Addendum #3

Project: 2024 – Fishers Elementary School Addition & Renovations

PROJECT NO: 2021119 DATE: 02/09/2024 BY: Josh Cannaday

A502

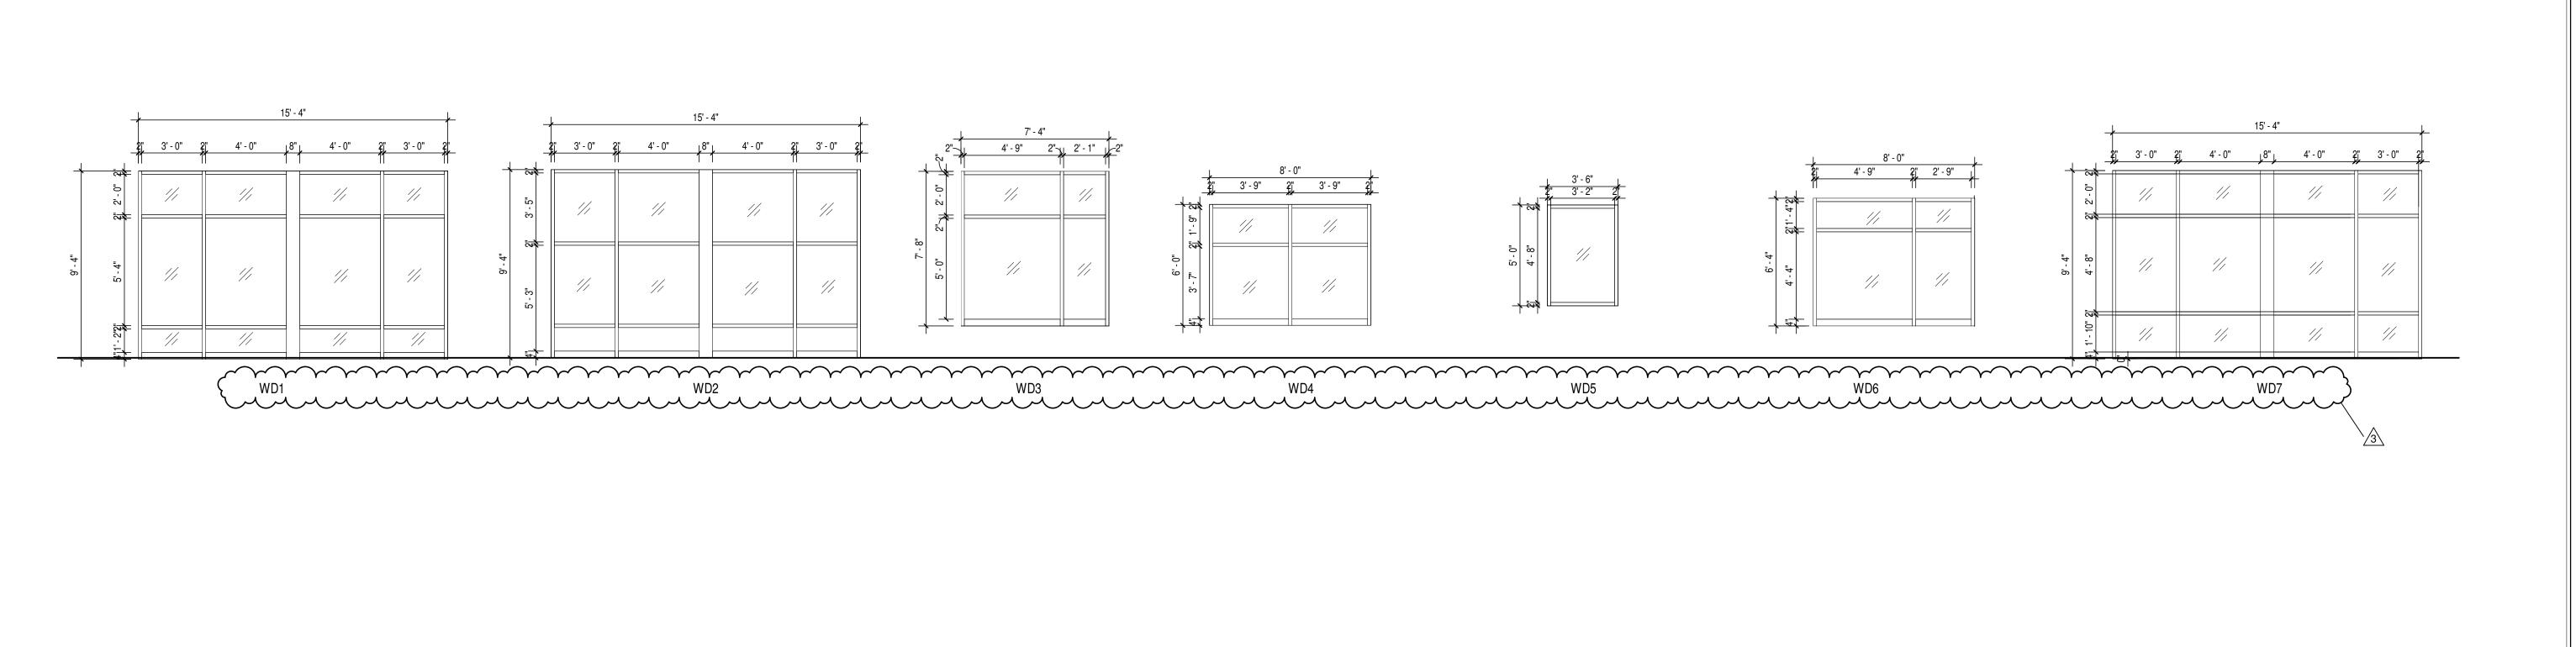
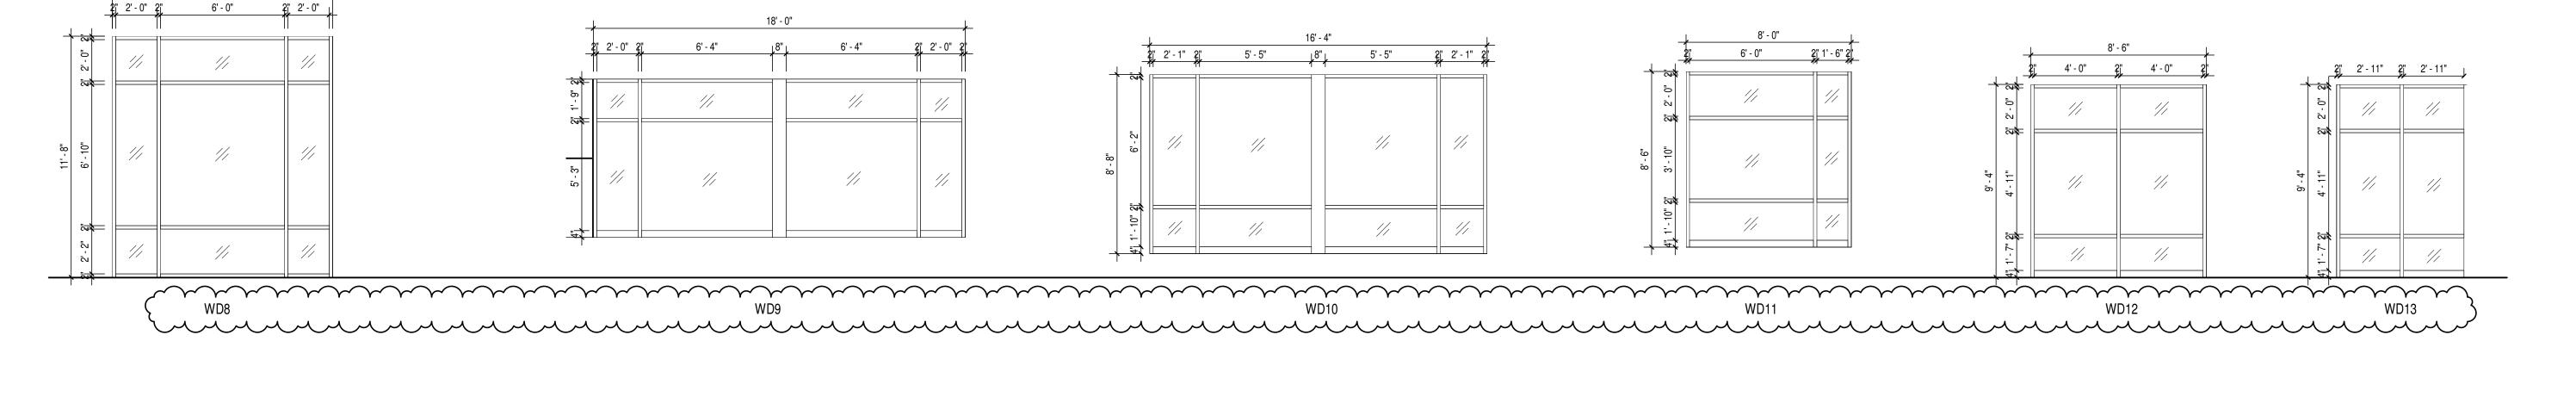
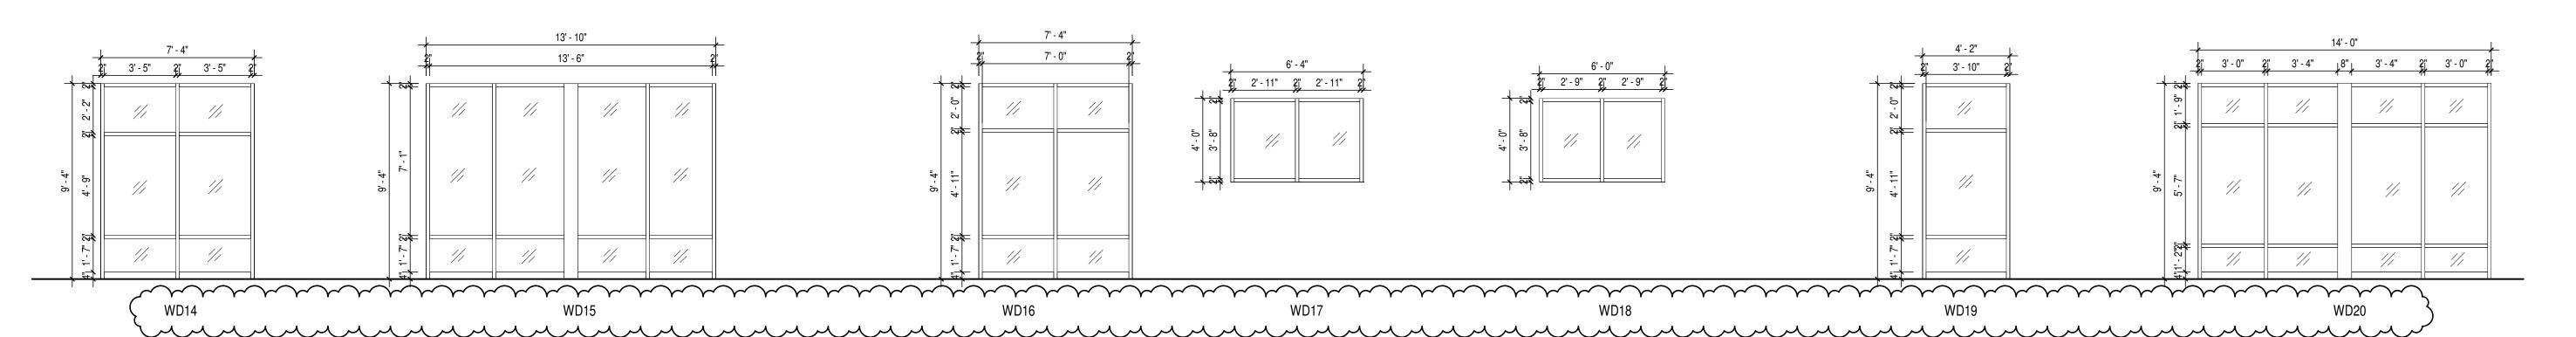
- B. Delete all instances of glazing type D from schedule.
- 4.22 A502 Door and Frame Elevations
 - A. Revise frames: F19, F21, F22, F24
- 4.23 <u>A503 Window Elevations</u>

A603

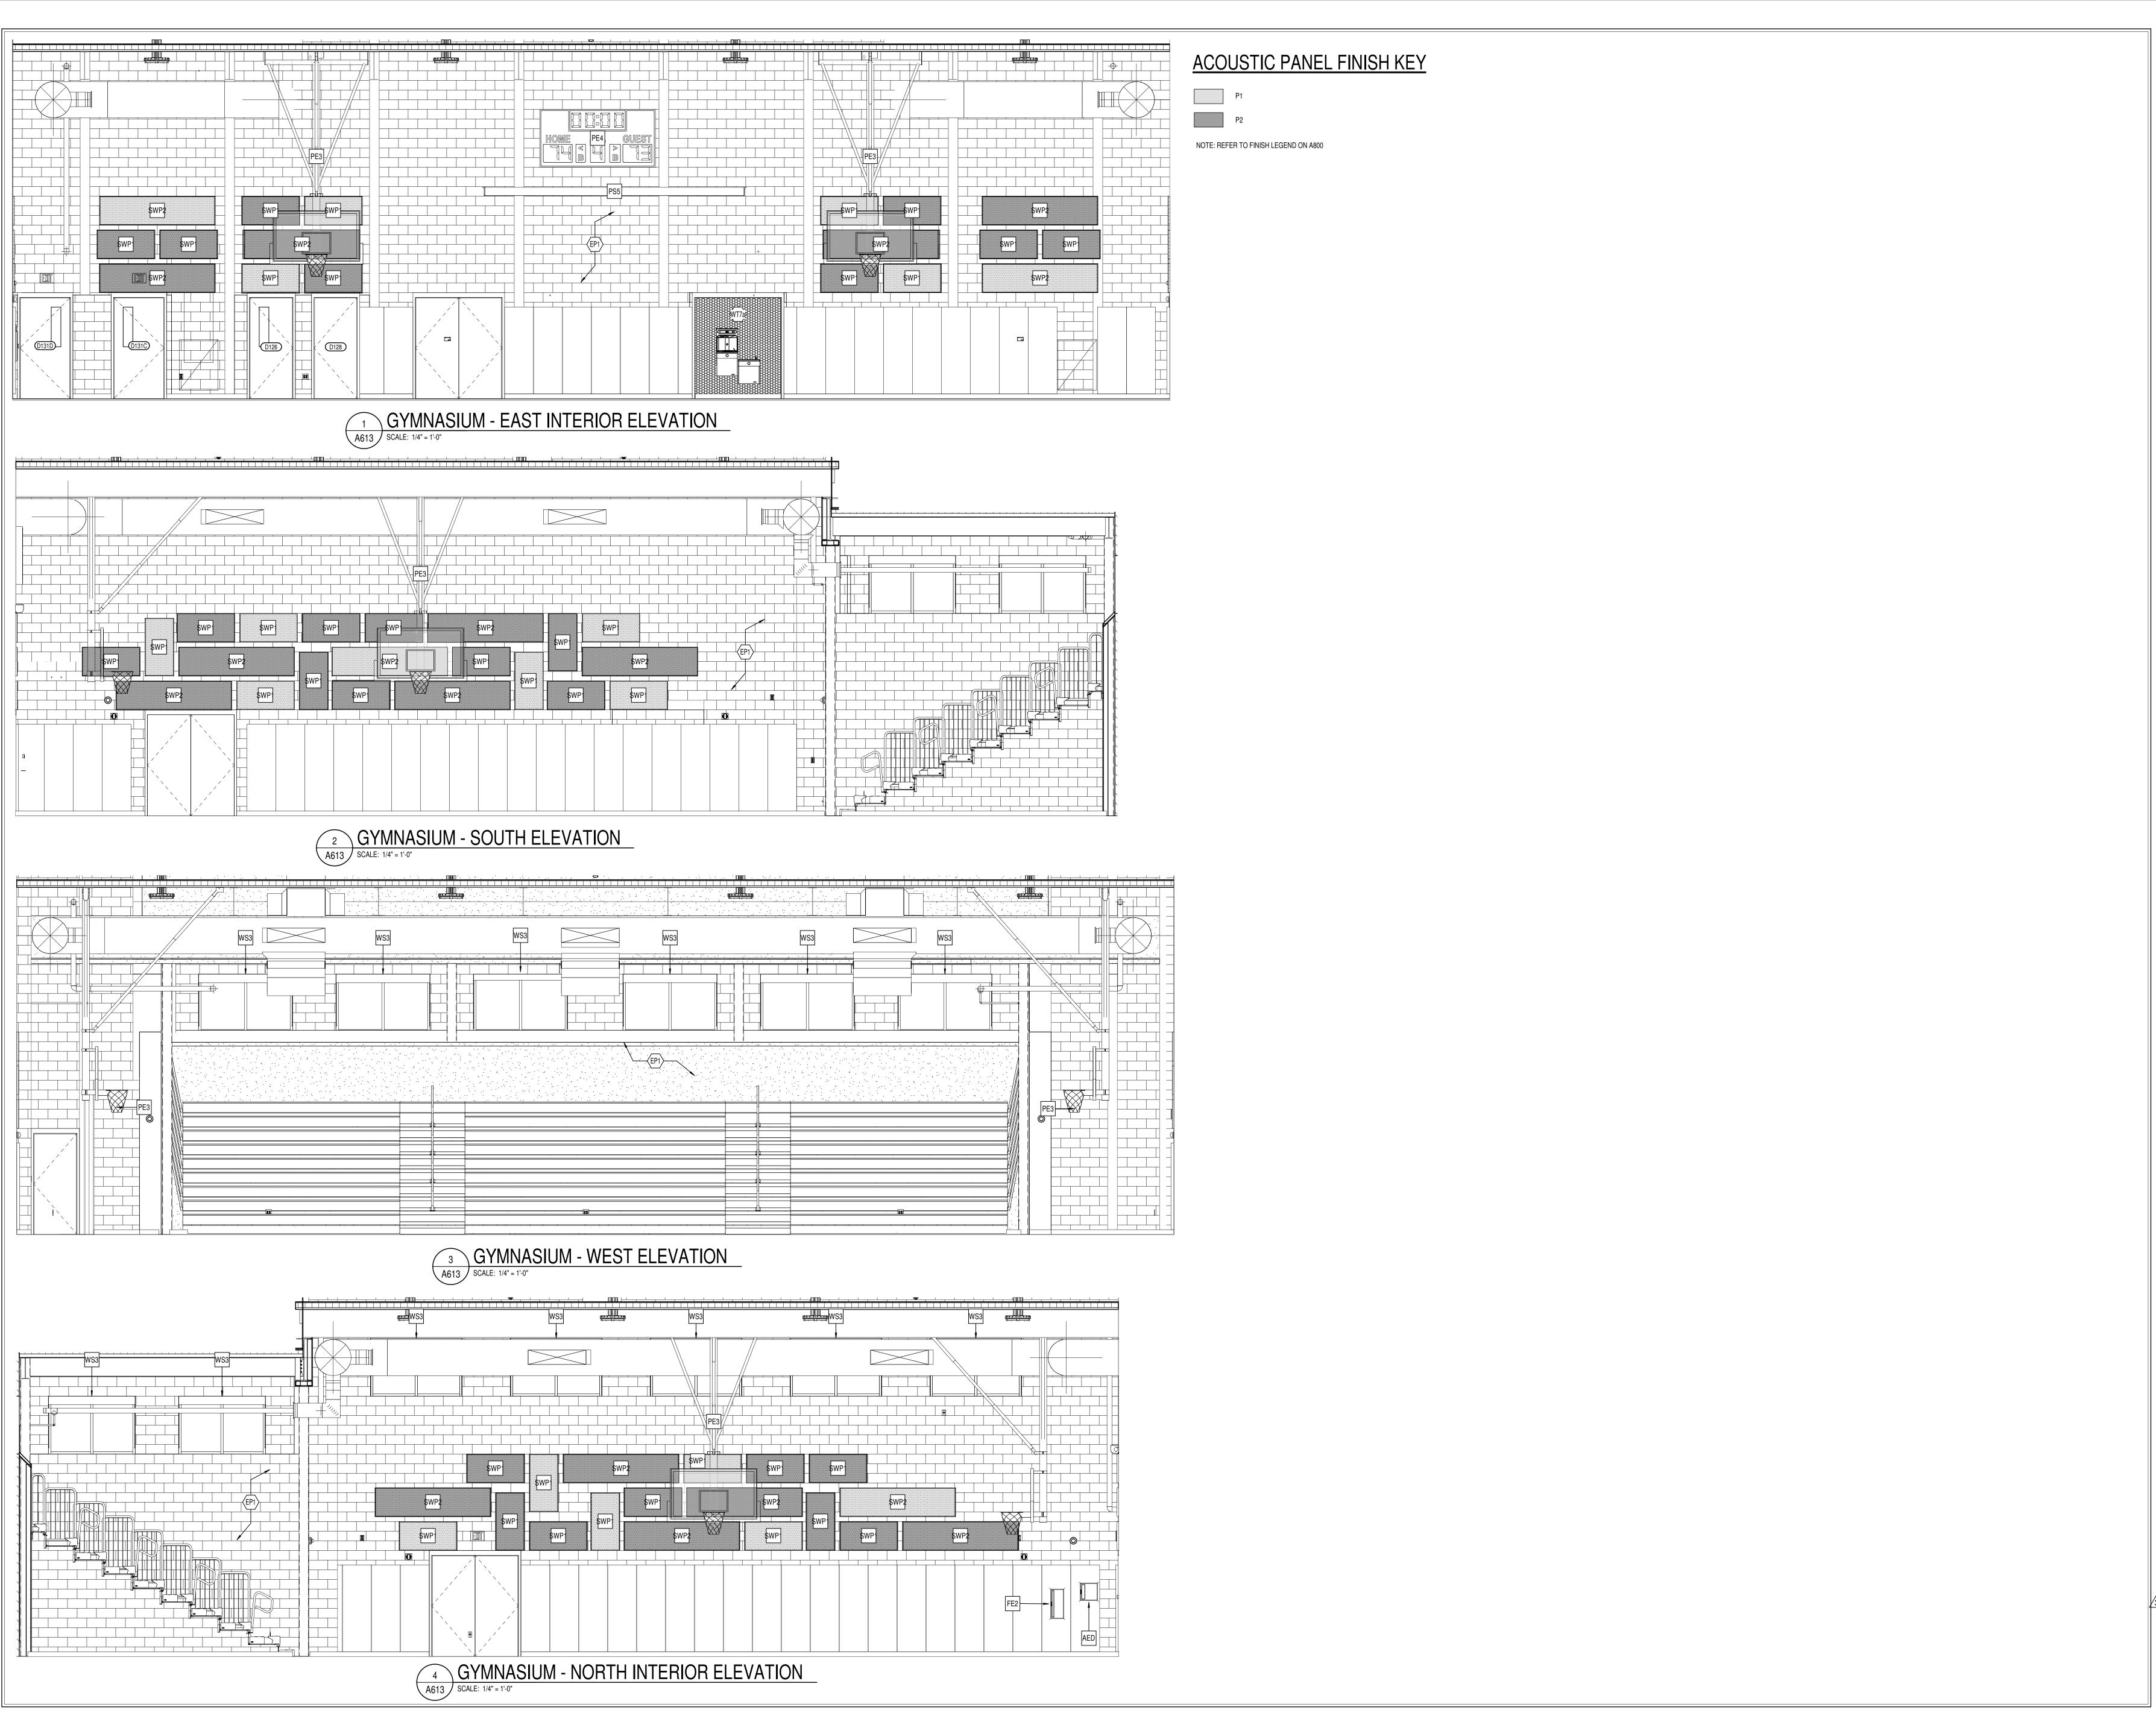
- A. Add Mothers C225A casework elevation to sheet
- 4.26 <u>A613 Interior Elevations Gymnasium</u>
 - A. Revise acoustic panel tags in gymnasium elevations
